ADDENDUM NO. 3

Tallapoosa County E911
Addition to the Tallapoosa County Jail Facility
Dadeville, Alabama

This Addendum No. 3, to the plans and specifications, dated 8 January 2026, consists of Two (2) Pages.

SD-2

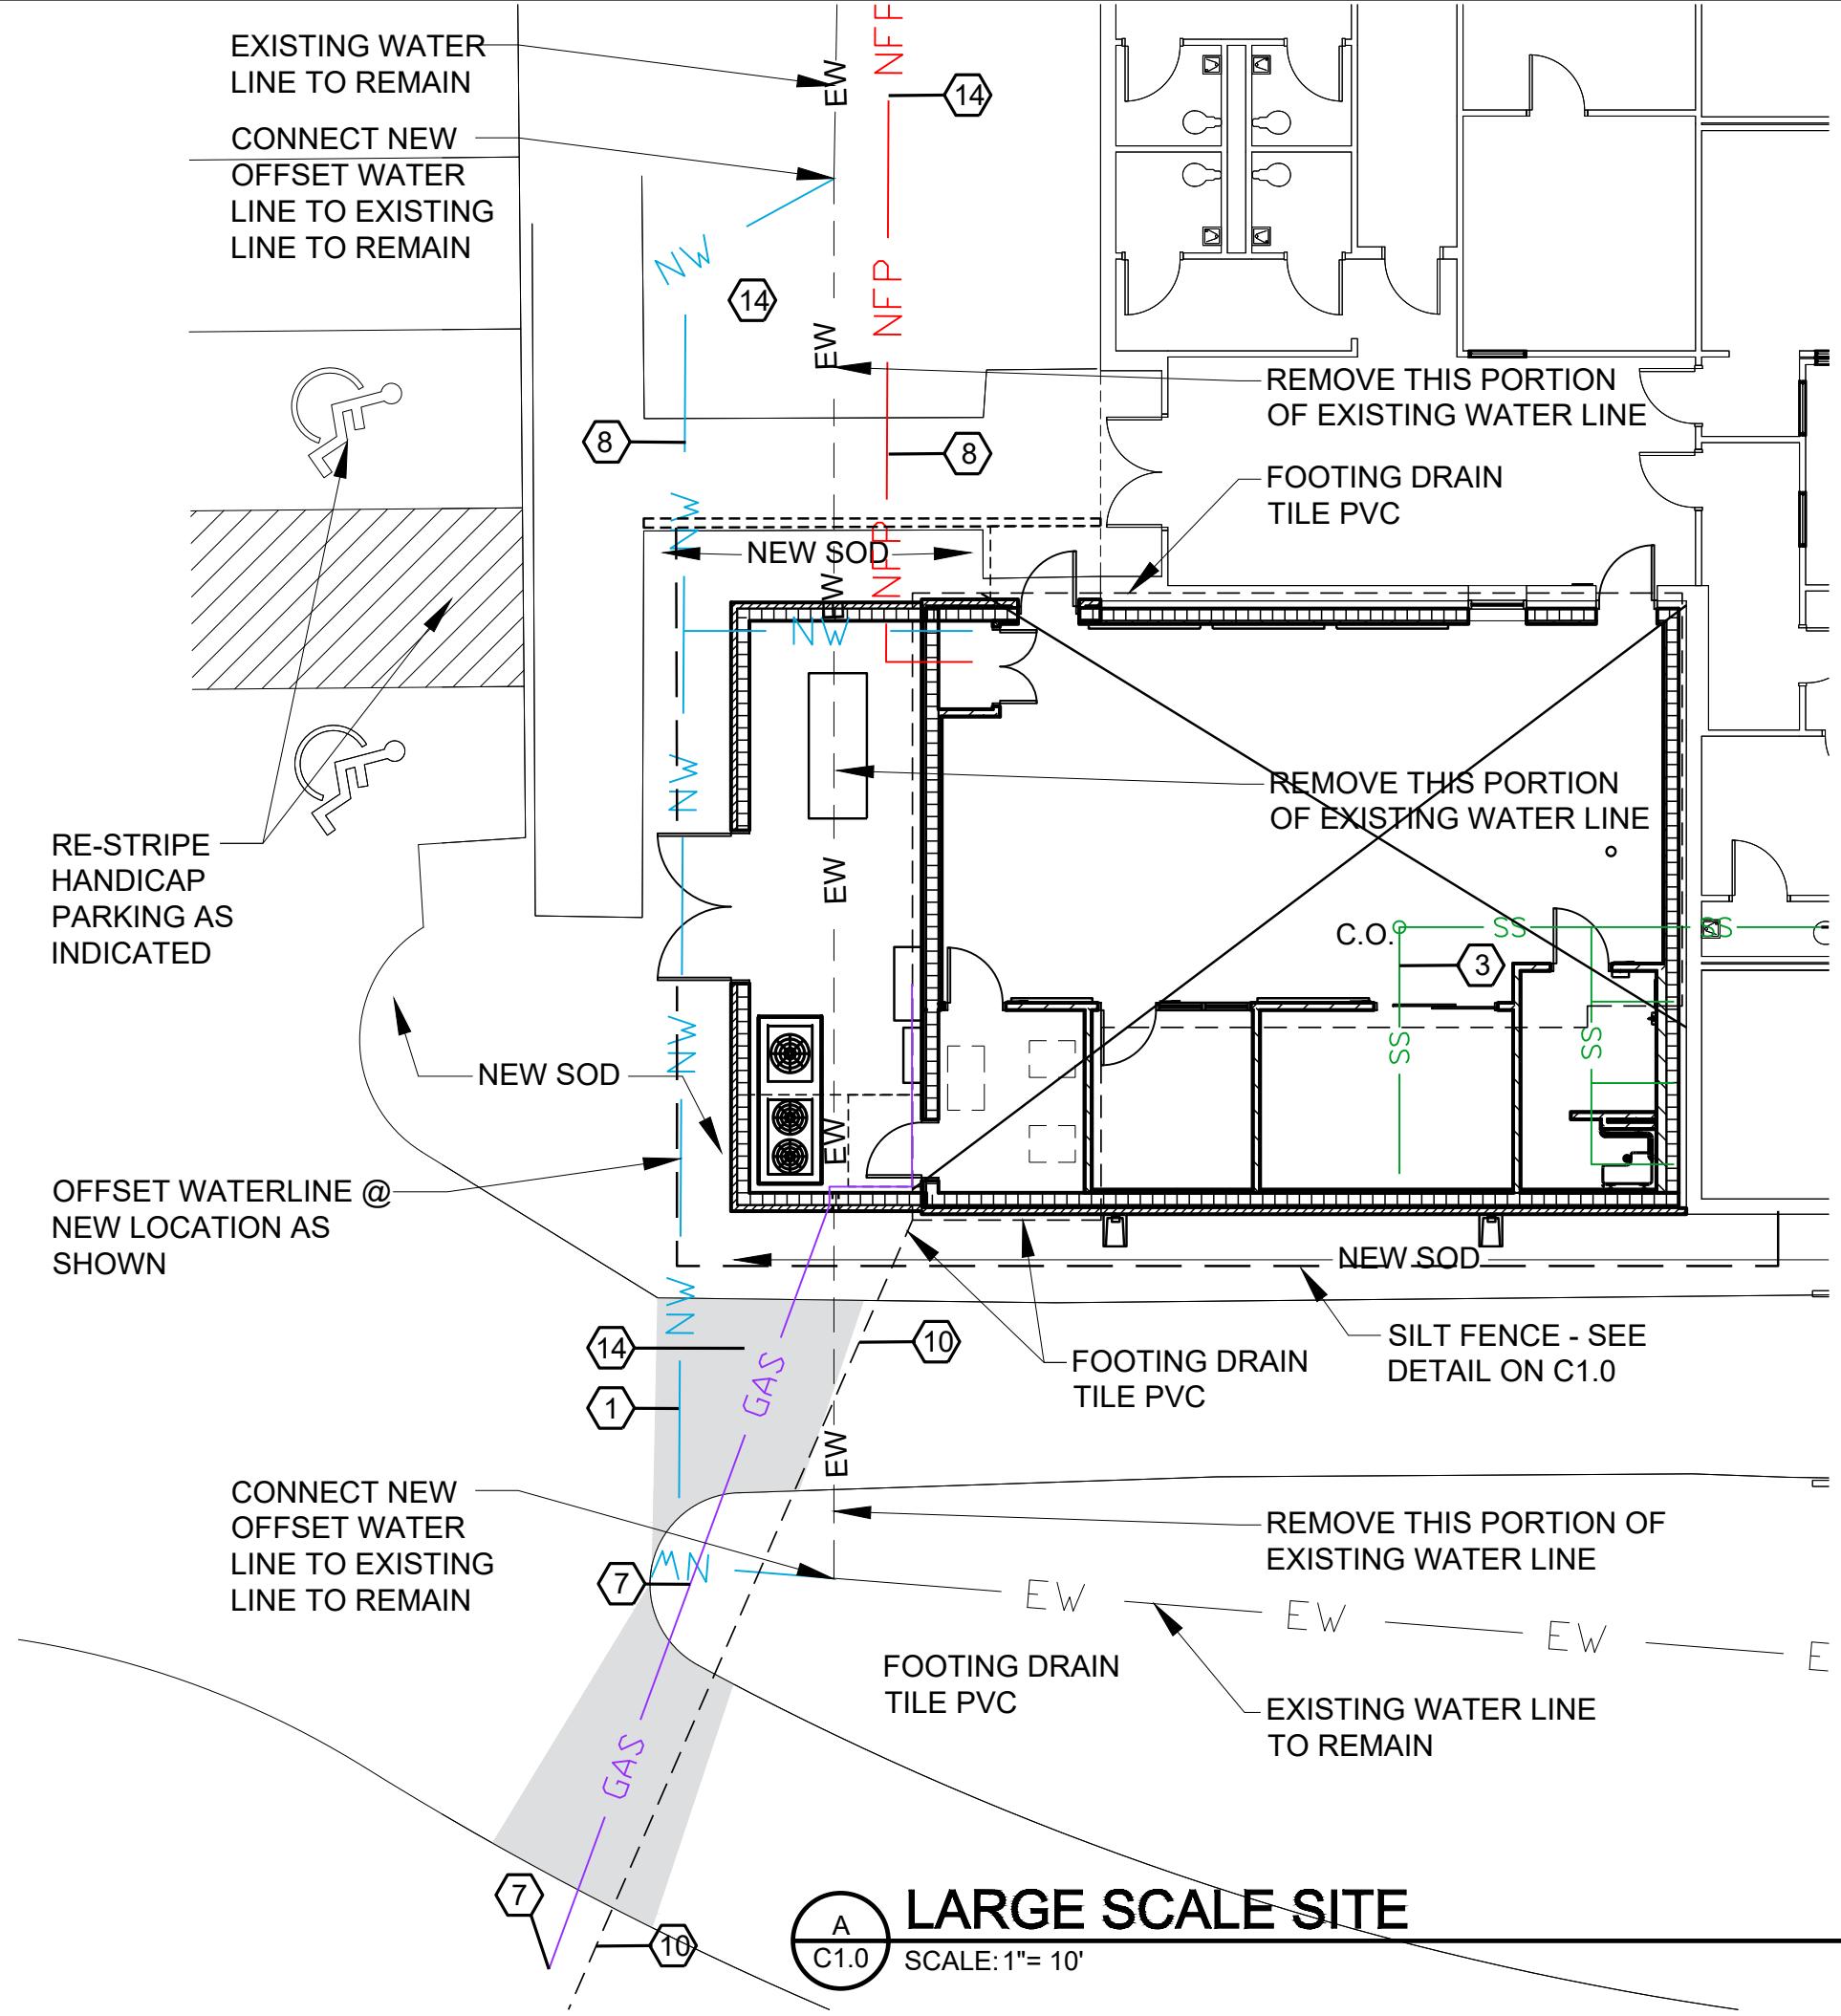
Item No. 1: Refer to Plans Sheet C1.0

A. **CLARIFICATION:** A portion of the existing water lines shall be removed and connected to the new water line that will offset around the new addition. See attached SD-2.
